**Planning & Development Division**  
Planning & Economic Development Department

File Number	PL 20-094	Contact	Kyle Deming	
Type	Special Use Permit for a Sanitary Sewer Lift Station	Planning Commission Date		July 14, 2020
Deadline for Action	Application Date	June 15, 2020	60 Days	August 14, 2020
	Date Extension Letter Mailed	July 2, 2020	120 Days	October 13, 2020
Location of Subject	2114 W. Michigan Street			
Applicant	City of Duluth, Public Works and Utilities Department, Engineering Division	Contact	Aaron Soderlund, Project Engineer	
Agent	N/A	Contact	N/A	
Legal Description	Parcel ID 010-1120-00105			
Site Visit Date	July 1, 2020	Sign Notice Date		June 30, 2020
Neighbor Letter Date	July 2, 2020	Number of Letters Sent		17

Applicant is requesting a new sanitary sewer lift station to replace the existing lift station, which will be demolished as part of MnDOT's Twin Ports Interchange Project.

LIFT STATION 15 RELOCATION  
CITY OF DULUTH, MINNESOTA  
2114 W MICHIGAN STREET

FILE NO. 00616135  
SHEET C-1

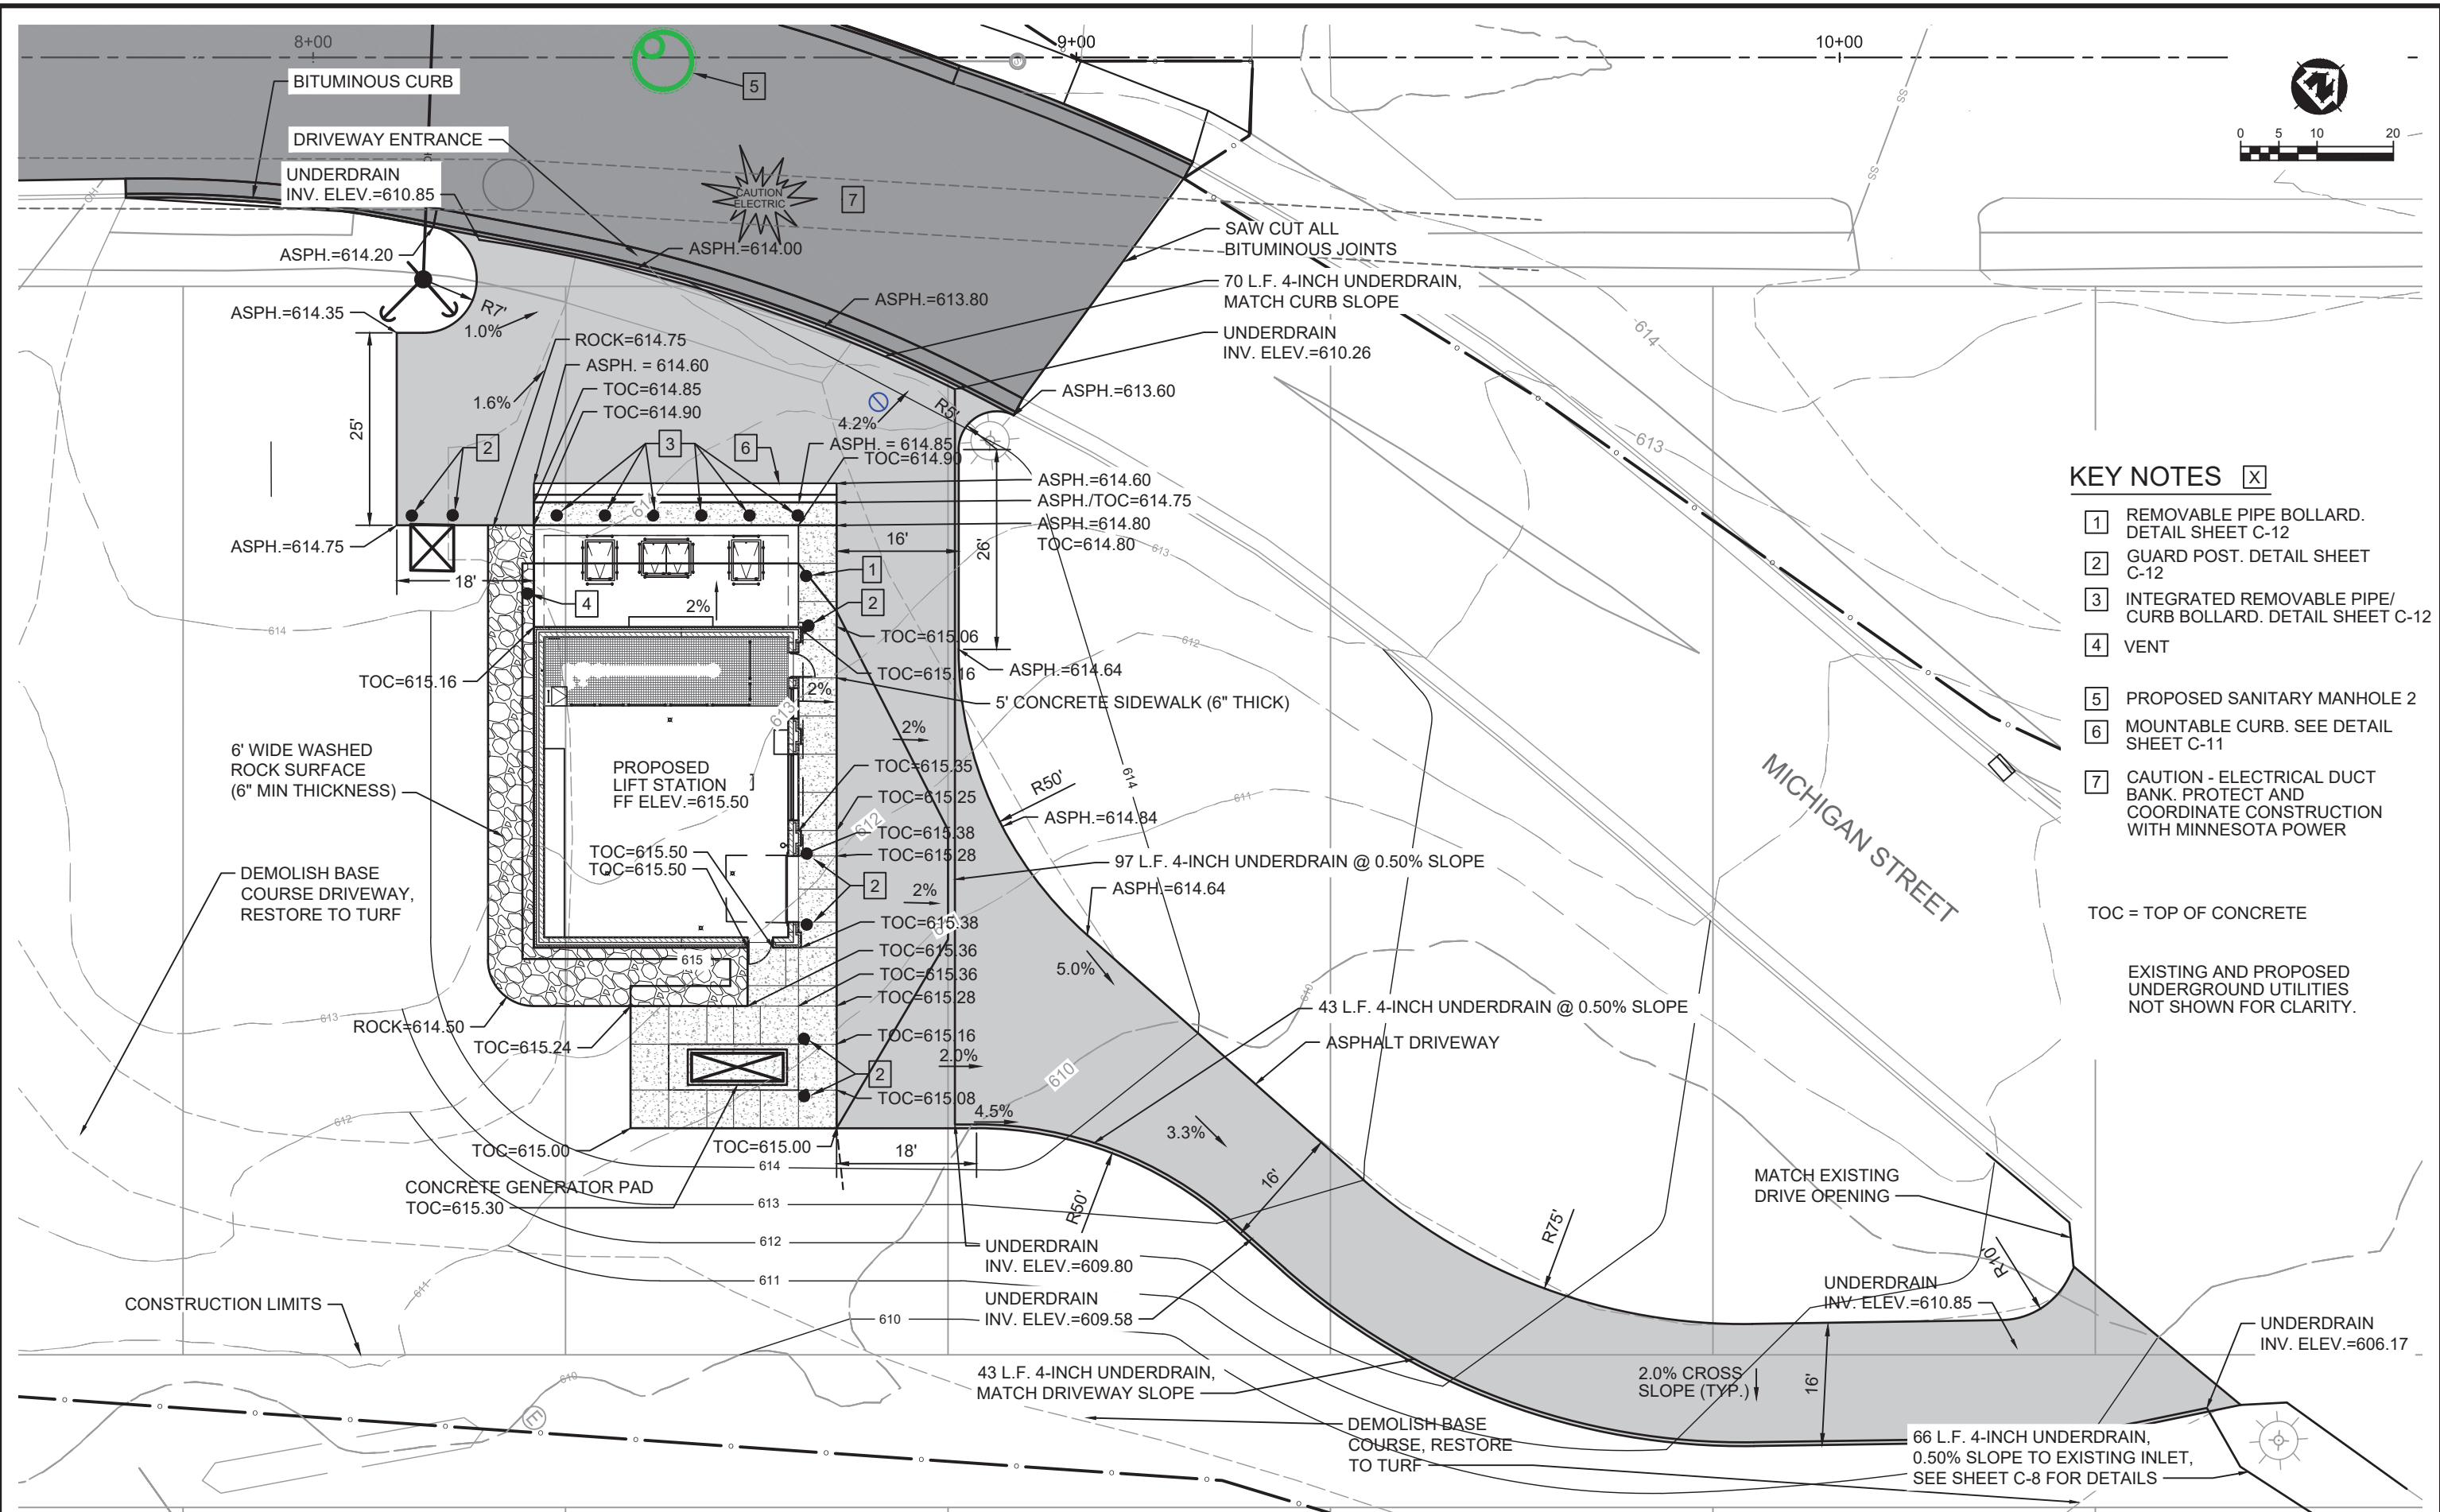
- 1) The project be limited to, constructed, and maintained in conformity with the following plans by MSA Professional Services titled "Lift Station 15 Relocation" Sheets A-1 (Perspectives), C-1 (Overall Site Plan), C-3 (Proposed Site Grading Plan), Sheet C-4 (Erosion Control Plan), Sheet C-8 (Pavement Restoration Plan, Sheet L-1 (Proposed Landscape Plan) and Sheet L-2 (Landscape Details); and
- 2) Any alterations to the approved plans that do not alter major elements of the plan may be approved by the Land Use Supervisor without further Planning Commission review; however, no such administrative approval shall constitute a variance from the provisions of Chapter 50.

FILE NO.  
00616135  
SHEET  
C-4

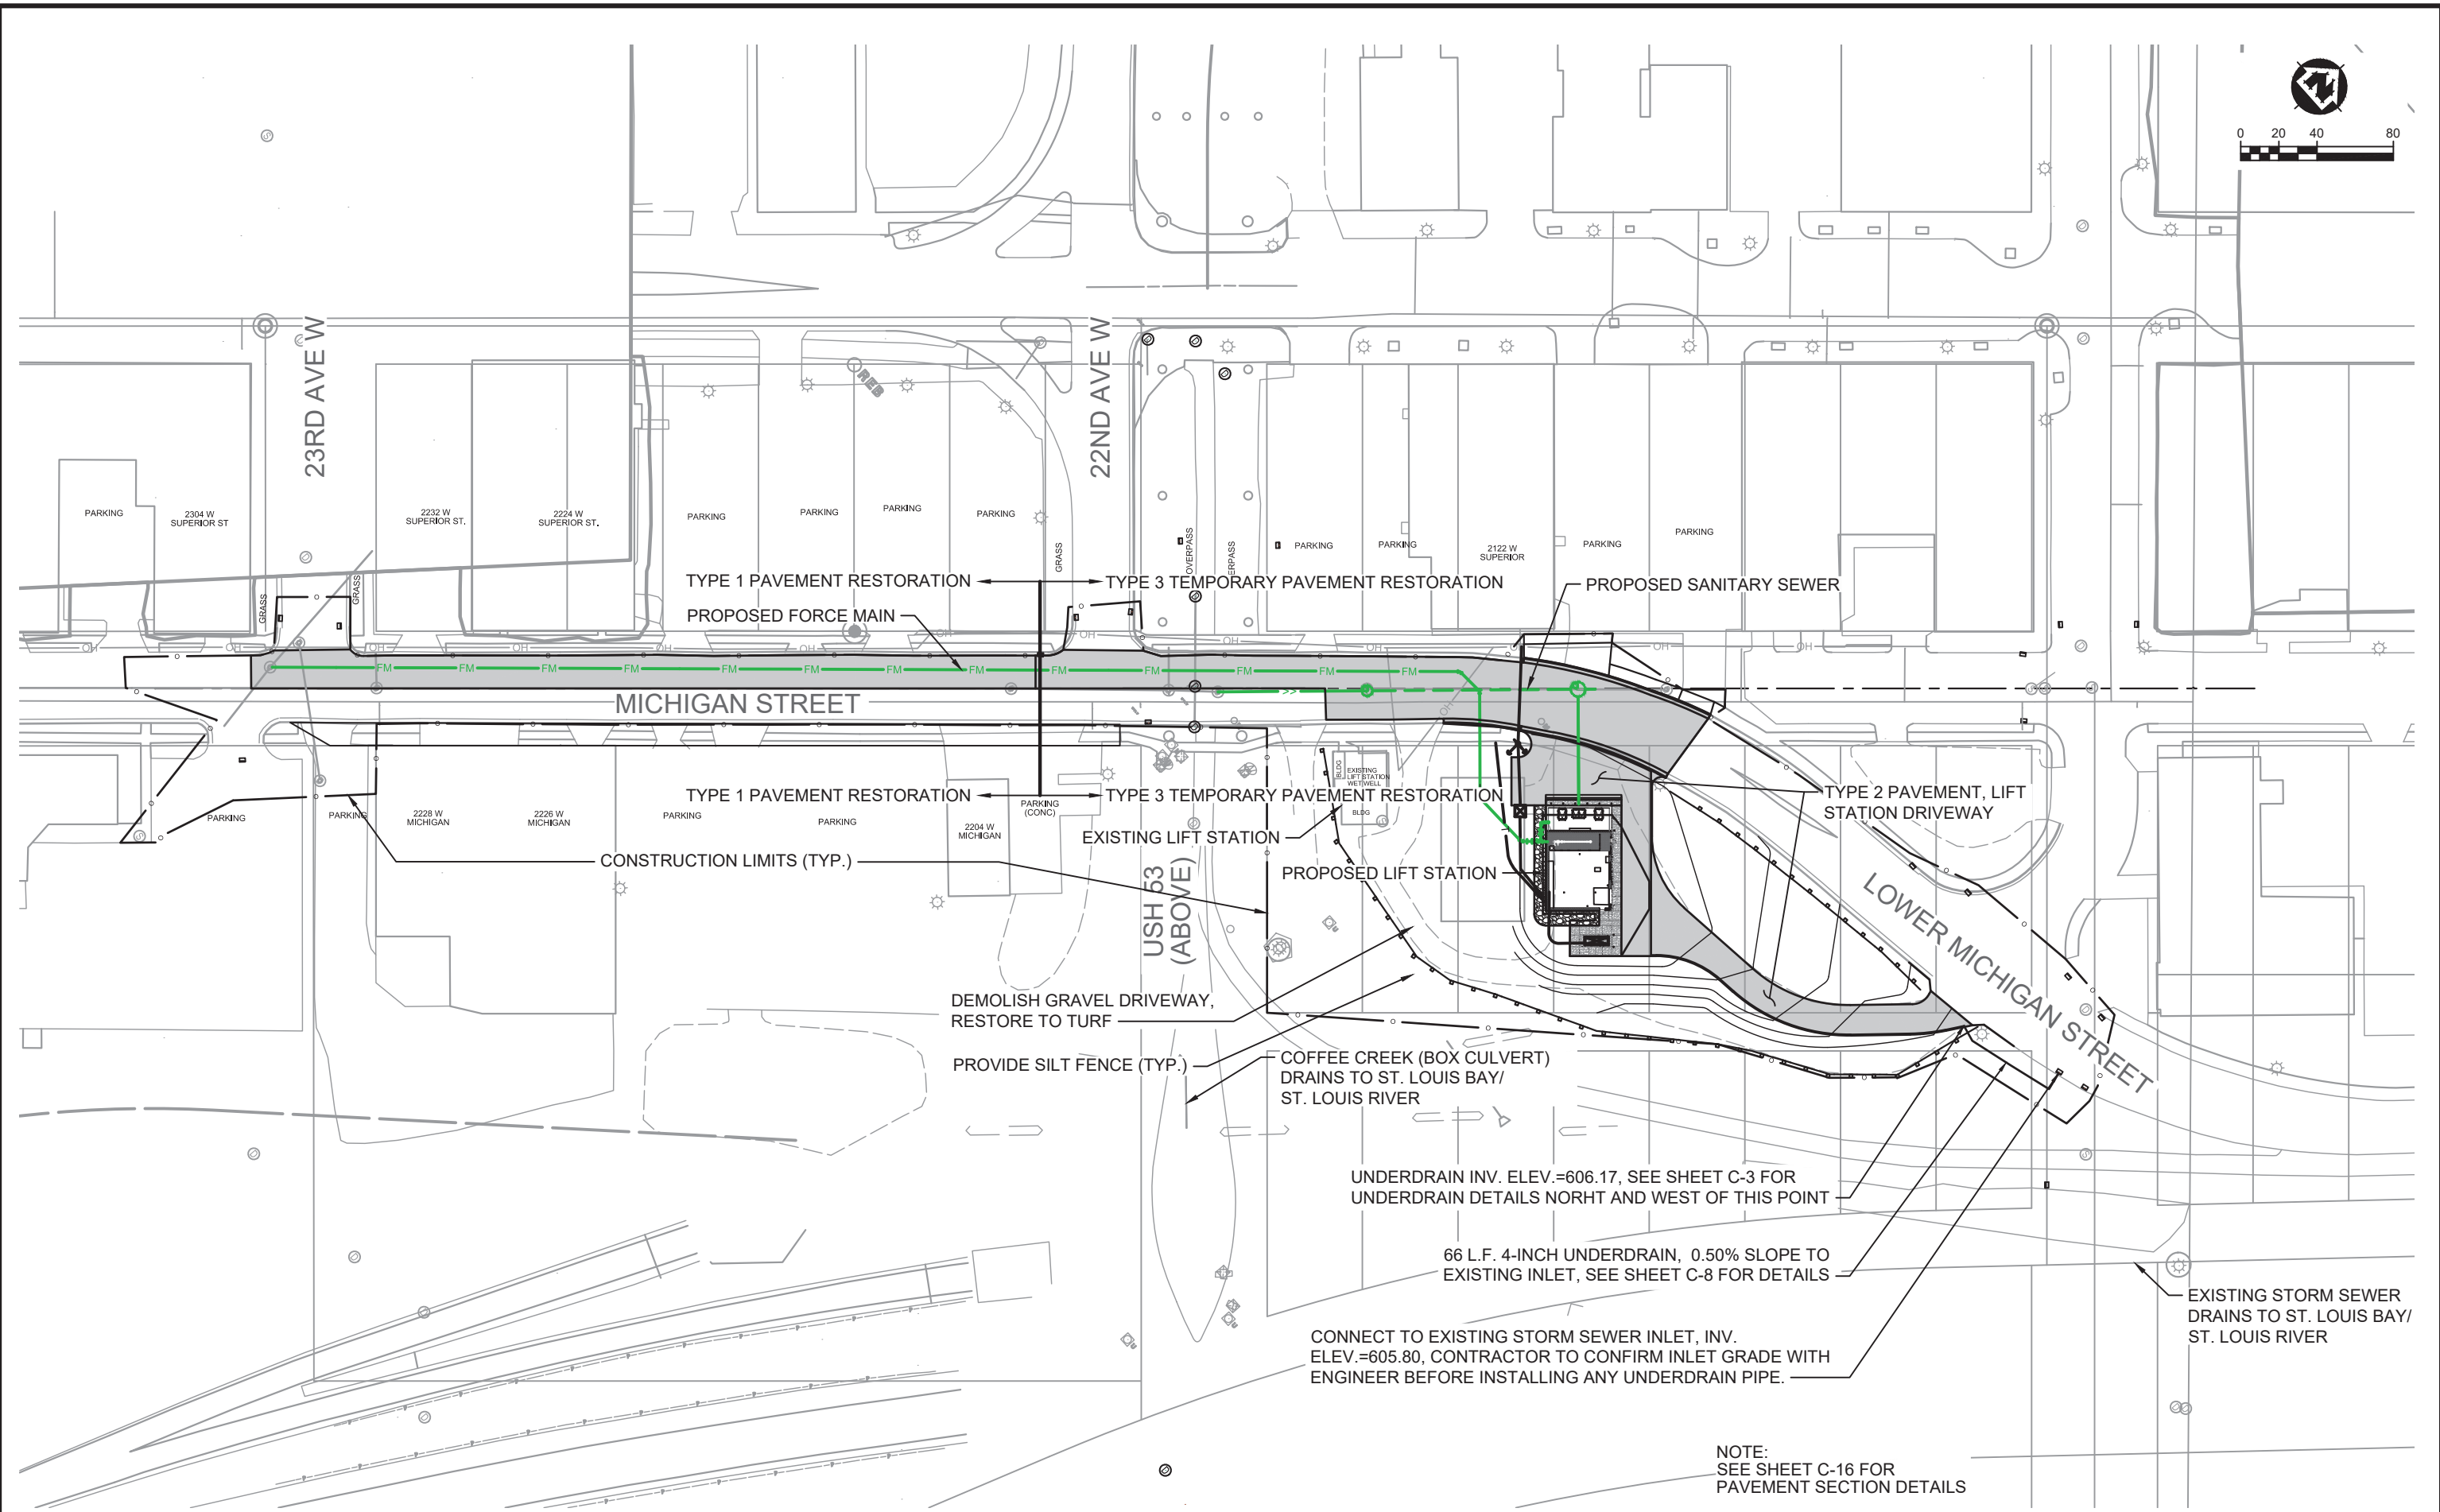
- 9) Sec. 50-28 (Stormwater Drainage and Erosion Control). From City stormwater engineer Tom Johnson: The site will be reducing the overall impervious surface (compared to the existing metal storage building and gravel parking lot currently on the site) once restoration is completed. The project will also include remediation of contaminated soils via removal and capping of those soils, and stormwater basins are not advised in this context. The runoff from the site will be treated with City-owned BMPs (best management practices), which include a pond to treat runoff from W. Michigan St., that will be installed during the Twin Ports Interchange project.
